2013 Part B adventure park.jpg

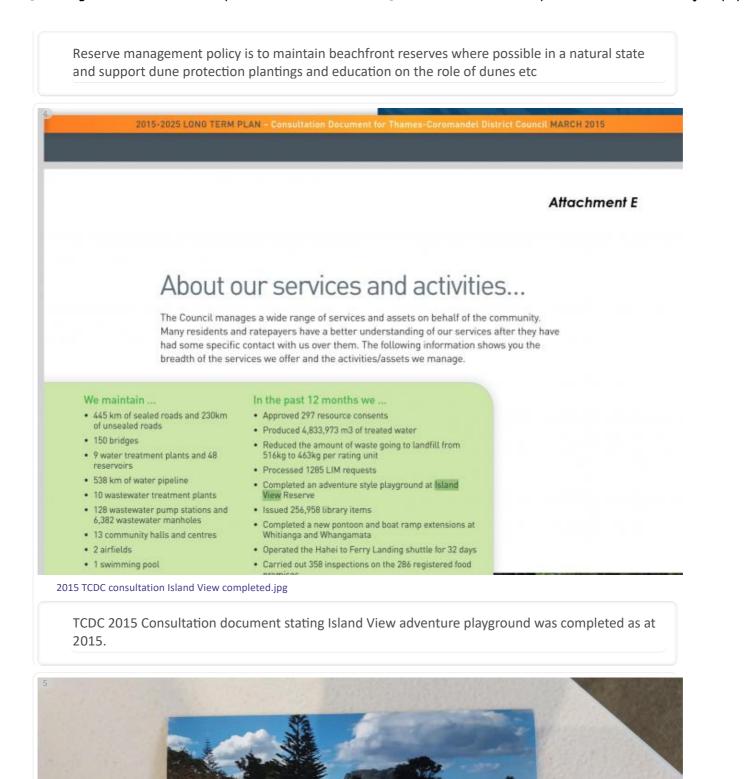
Note the detention/basin is visible but covered in vegetation

Ie the adventure park application acknowledged the detention area. The vegetation indicates that its not being maintained.

20230307_084914.jpg

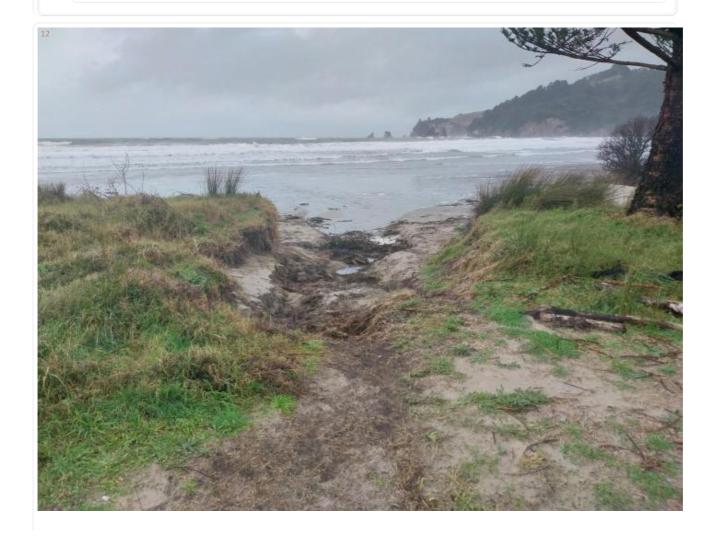
Compare dunes now - the Norfolk Pine is now in danger of erosion with the sand dunes lost to the left.
